Access Compliance Report

Public Rights-of-Way

(Pedestrian Signals)

Intersection ID: N/A	Main Street:	Cross Street: N/A	Location: N/A
ADA ID: 250FB958F18A	Signal Type: One Push Button-Non APS	Overall Compliance: No	Severity Score: BTN 1: N/A BTN 2: N/A No BTN: N/A
Codes/Mitigation Info/Possible Solution		Field Measurements/Component Compliance

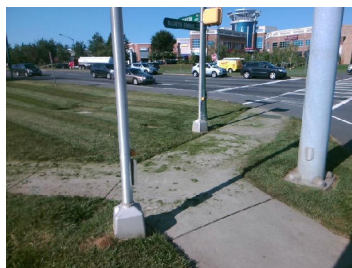
PROW/ADA: TMUTCD 4e.08, R404.2, R406.2

Possible Solutions: Replace Signal Push Button With APS Button on New Post. Remove & Relocate Sign.
